MONTEREY PENINSULA WATER MANAGEMENT DISTRICT

**ADDENDUM NO. 1
TO
CONTRACT DOCUMENTS**

**For Construction
Of
BACKFLUSH BASIN EXPANSION PROJECT**

This Addendum (including attachments), dated August 30, 2018, includes 19 pages.

DEMOLITION PLAN
MONTEREY PENINSULA WATER MANAGEMENT DISTRICT
SANTA MARGARITA ASR FACILITY SITE EXPANSION
1910 GENERAL JIM MOORE BOULEVARD

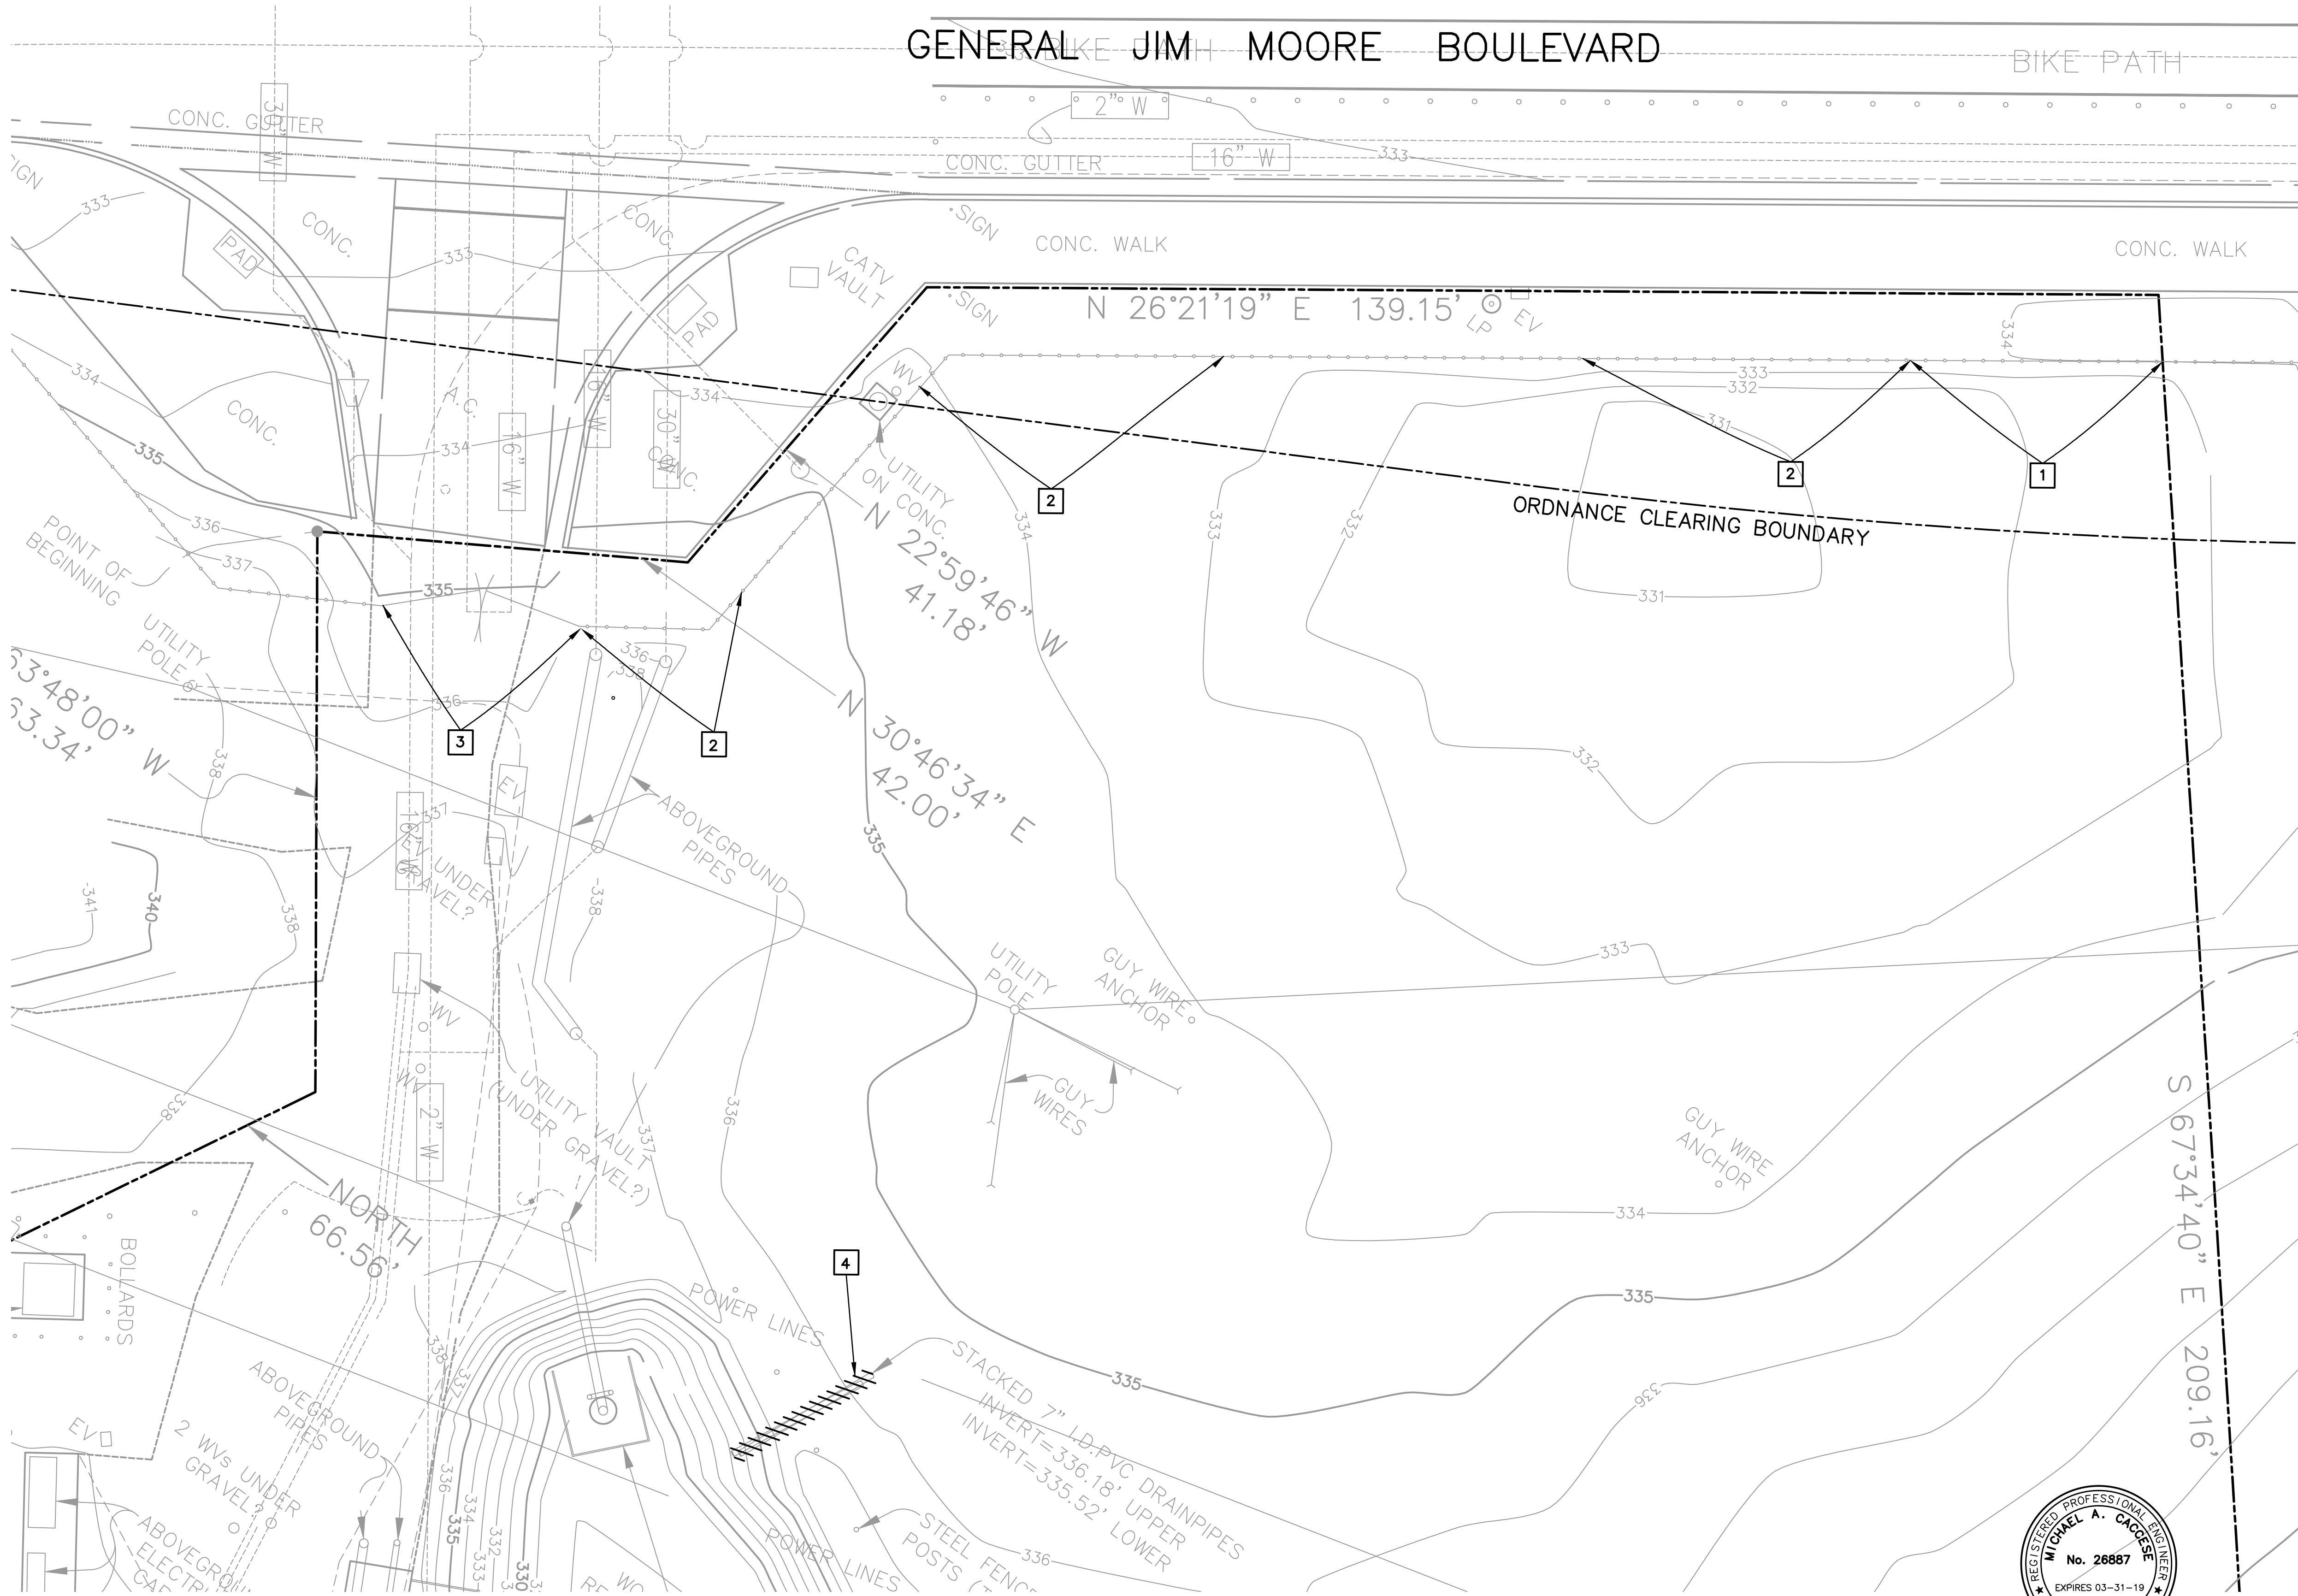
Drawings and Specifications, Drawing 3 and Drawing 4

Add the following Notes:

- 1. The gate must be reinstalled in the original or Owner-approved location.*
- 2. Operations access must be maintained at all times.*
- 3. Site security must be maintained at all times.*

FINAL GRADING PLAN
MONTEREY PENINSULA WATER MANAGEMENT DISTRICT
SANTA MARGARITA ASR FACILITY SITE EXPANSION
1910 GENERAL JIM MOORE BOULEVARD

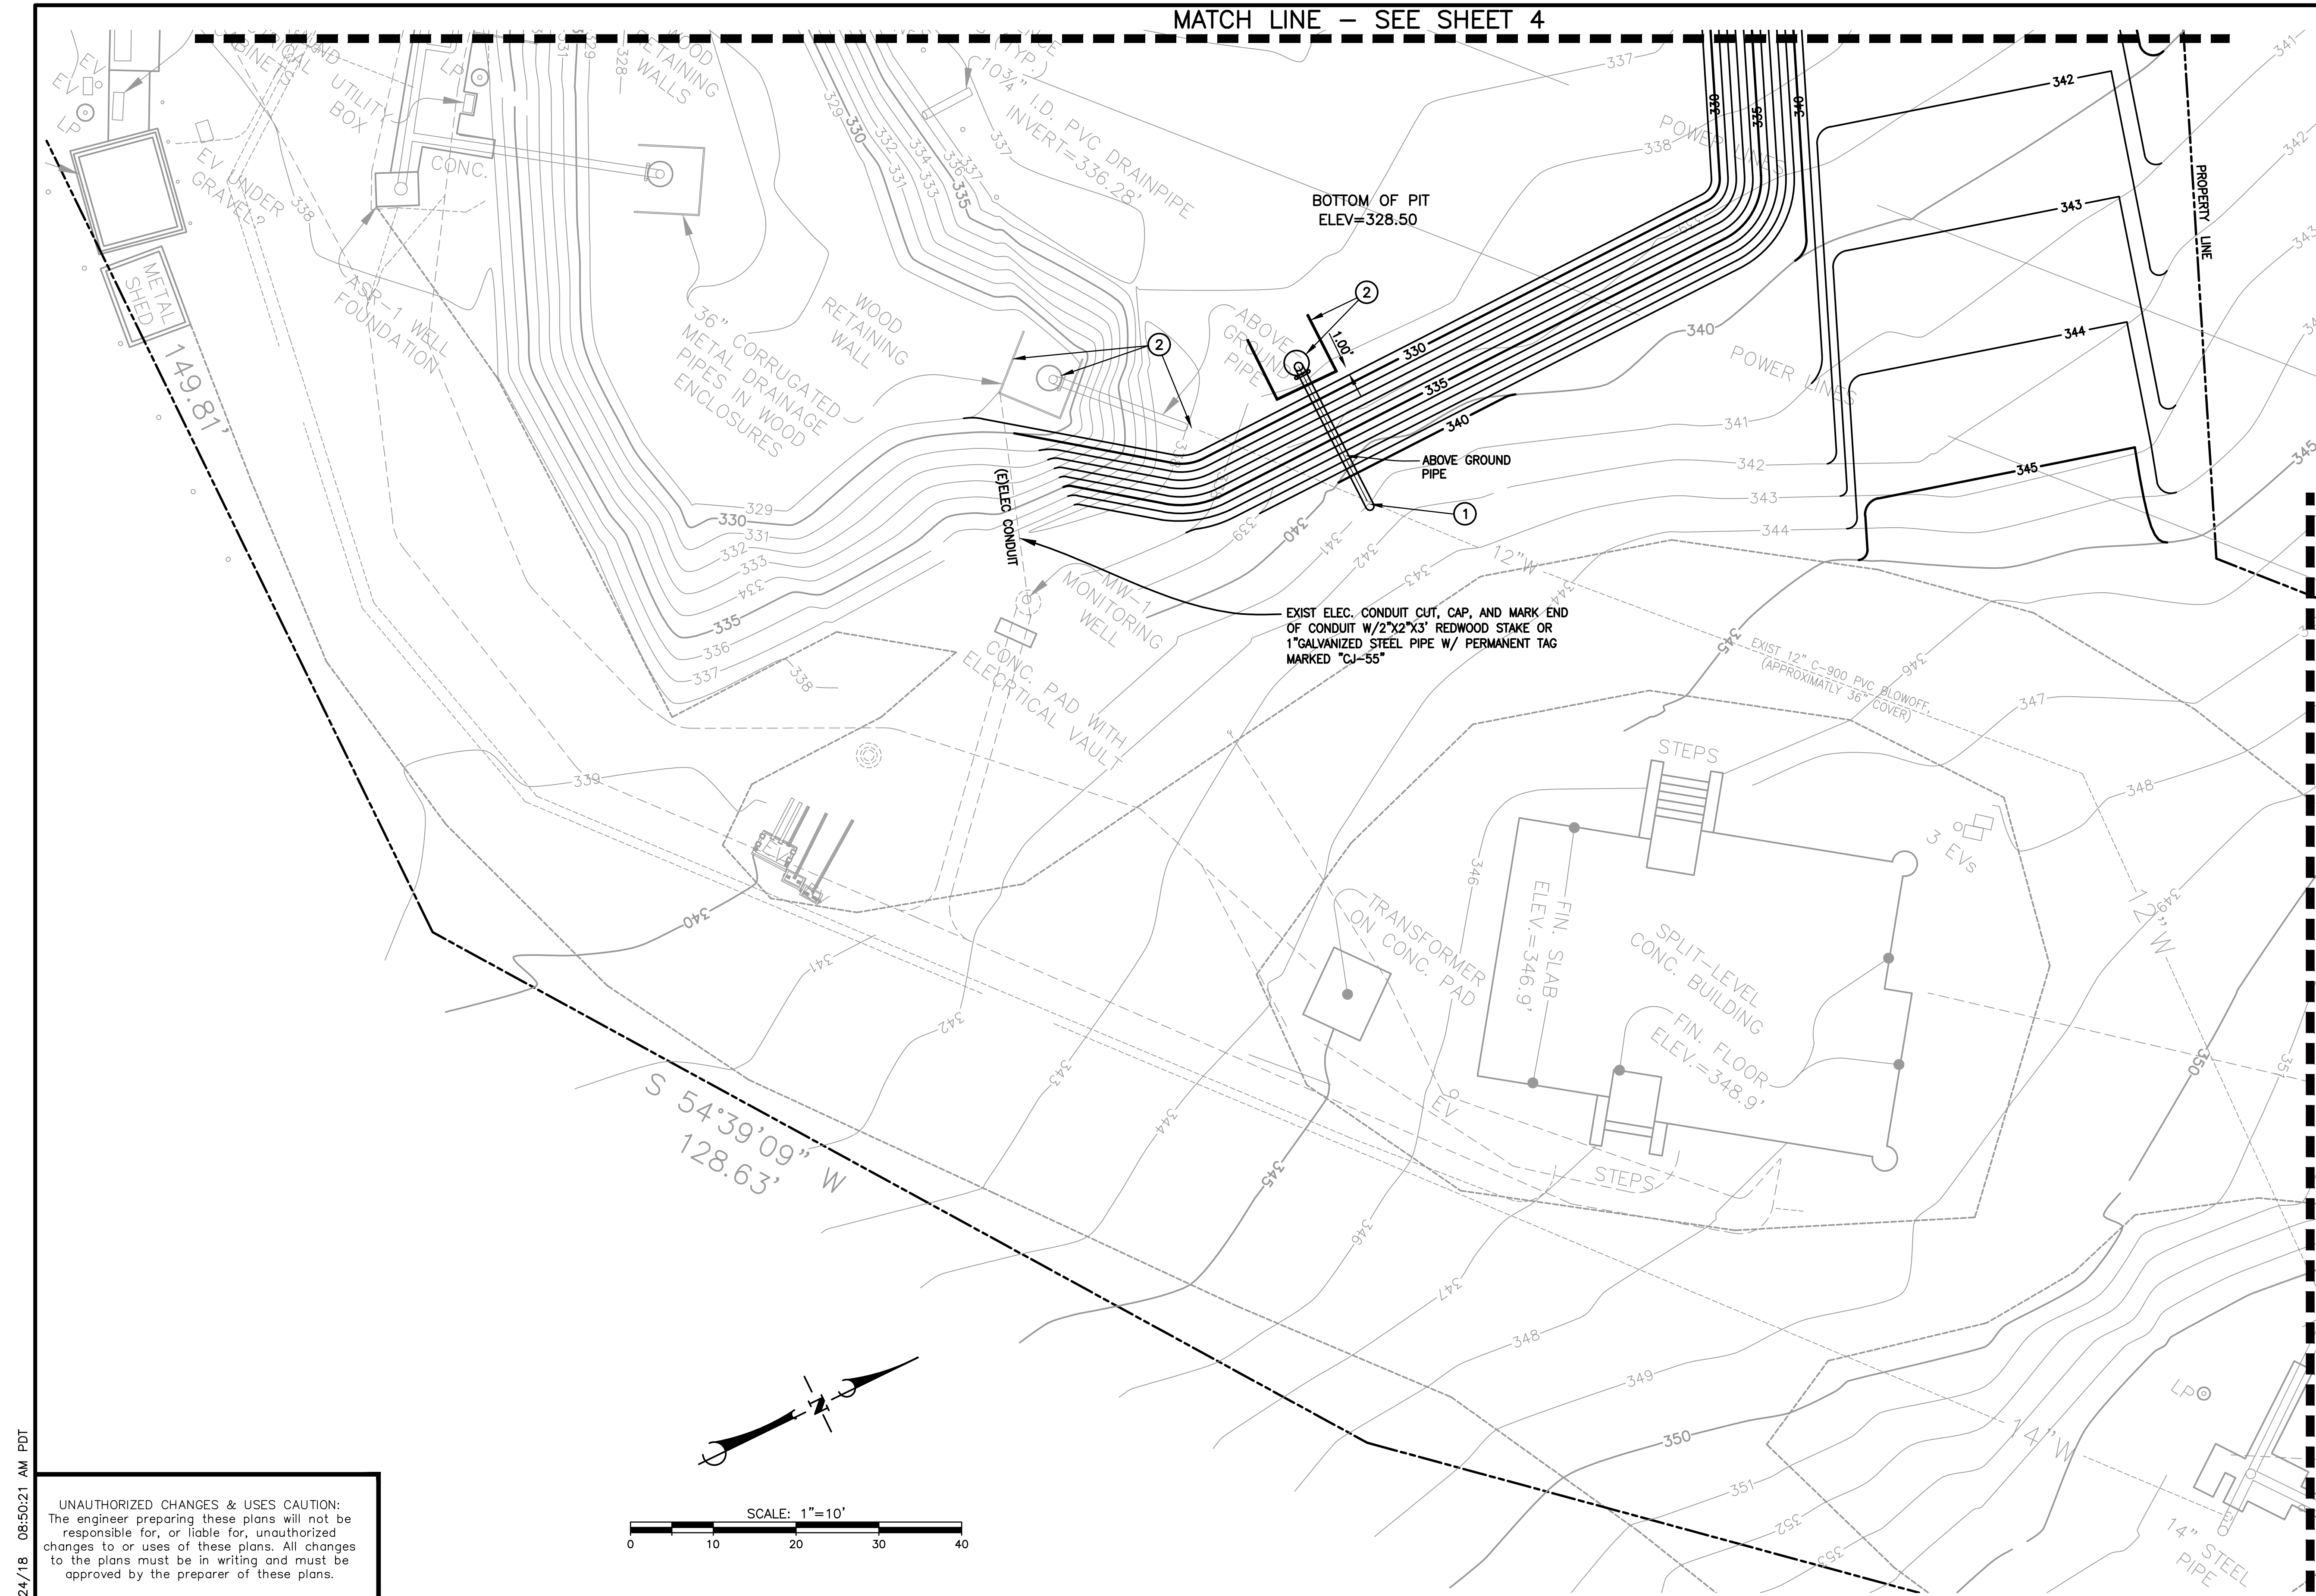
Drawings and Specifications, Drawings 5 and 6

Add the following note:

The price to furnish or provide new materials shall be included in the bid price.
